Access Compliance Report

Public Rights-of-Way

Intersection ID: 4075	Main Street: OVERLOOK_MOUNTAIN_DR	Cross Street: MOUNTAIN_COVE_DR	Location: S
ADA ID: C1551118BAFC	Ramp Type: BlendTrans2	Initial Pass/Fail: Fail	Overall Compliance: No
		Severity Score: 1.25

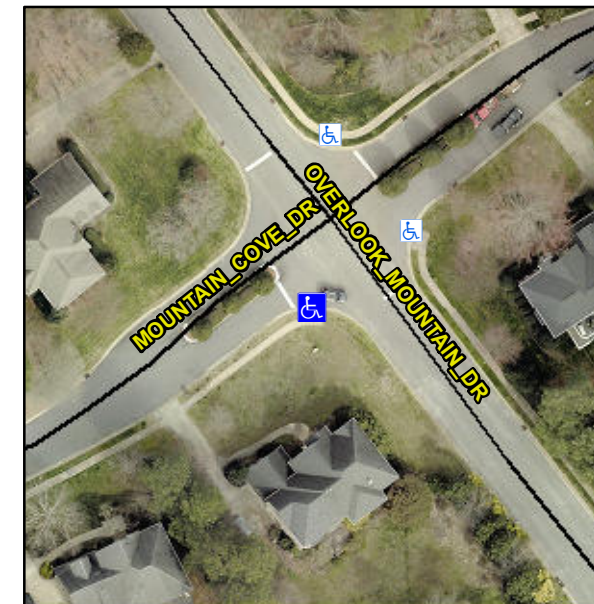
Not Found, R304.5.3

Compliance	Description	Data	Compliance	Description	Data
N/A	Ramp Length (in)	94.0	Yes	BlendTrans Slope (%)	3.9
Yes	Ramp Width (in)	48.0	No	BlendTrans XSlope (%)	2.2
N/A	Flare Type LT	N/A	N/A	Flare Type RT	N/A
N/A	Flare Slope LT (%)	N/A	N/A	Flare Slope RT (%)	N/A
N/A	Flare Traversable LT?	N/A	N/A	Flare Traversable RT?	N/A
N/A	Landing Length (in)	N/A	N/A	DWS Provided?	N/A
N/A	Landing Width (in)	N/A	N/A	DWS Contrast?	N/A
N/A	Landing Slope (%)	N/A	N/A	DWS Length (in)	N/A
N/A	Landing X Slope (%)	N/A	N/A	DWS Full Width?	N/A
N/A	Landing Curb? (Y/N)	N/A	N/A	DWS Offset (in)	N/A
N/A	Shared Landing?	N/A			
N/A	Gutter Ponding?	N/A	N/A	Gutter Slope (%)	N/A
N/A	Gutter Lip Ht (in)	N/A	N/A	Gutter X Slope (%)	N/A
N/A	Painted X Walk1?	No	N/A	Painted X Walk2?	N/A
	X Walk 1 Direction	To NE		X Walk 2 Direction	N/A
	X Walk 1 Width (in)	N/A		X Walk 2 Width (in)	N/A
	X Walk 1 Slope (%)	5.5		X Walk 2 Slope (%)	N/A
	X Walk 1 X Slope (%)	5.4		X Walk 2 X Slope (%)	N/A

Remove & Replace Curb Ramp With Two New Directional Ramps or Equivalent.
